Pedestrian & Bicycle Consideration Review

**Nelson County
Project # 04-8809.00
Constructing a new route to bypass downtown
Bardstown**

Prepared by:
Troy Hearn
Division of Planning
Kentucky Transportation Cabinet
February 14, 2019

Figure 2 / Strava Global Heat Map for Bicycle Travel / <http://labs.strava.com/heatmap/#12/-85.48582/37.82402/gray/bike>

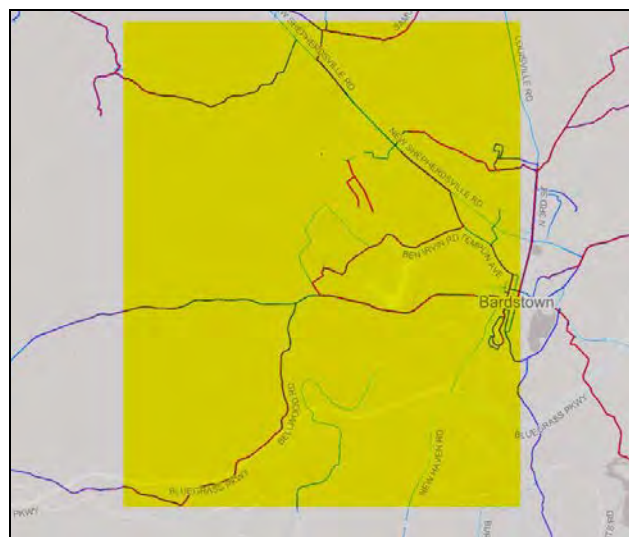
- KY-245 / MP 5.5-7.0
 - a. ADT range is 13000-20000
 - b. Posted speed limit is 55 MPH
 - c. Paved shoulder 5' or wider
 - d. Rural cross section design
 - e. Low estimates for bicycle travel volumes (Figure 2)
 - f. The Bicycle Comfort Index (BCI) average rating is a level C

- US-62 / MP 10-12
 - a. ADT range is 2200-4500
 - b. Posted speed limit is 55MPH
 - c. No paved shoulder
 - d. Rural cross section design
 - e. Low to moderate estimates for bicycle travel volumes (Figure 2)
 - f. The Bicycle Comfort Index (BCI) average rating is a level D

Figure 3 / Bicycle gaps within the rumbles / http://safety.fhwa.dot.gov/roadway_dept/pavement/rumble_strips/t504039/

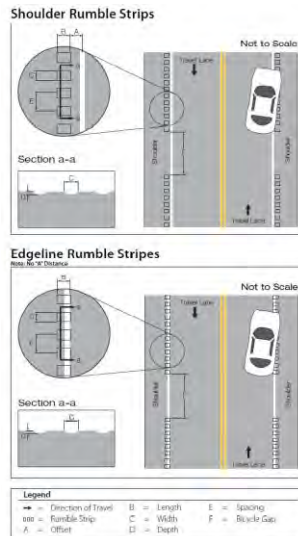
Best: Construct a shared use path (10' or wider) along the entire new route on the eastern side of the roadway. Construct paved shoulders (6' or wider) along both side of the roadway and provide a 10' gap in the rumble strips every 40-50' (see Figure 3). An agreement should be created between KYTC and the local government explaining the maintenance details for this facility. The BCI average rating would be a level A (dedicated facility).

Good: Provide a constructed berm for a shared use path (10') along the northern section of the new roadway (from US-31E, across KY-245 and then to US-62) and construct shoulders on both sides of the roadway, (6' or wider). Provide a gap of 10' every 40-50' within the rumble strip (see Figure 3). The BCI average rating would be a level B. An agreement should be created between KYTC and the local government explaining the maintenance details for this facility.

Fair: For Rural Cross Section / Construct a paved shoulder on both sides of the roadway (6' or wider). Provide a gap of 10' every 40-50' within the rumble strip (see Figure 3). The BCI average rating would be a level C.
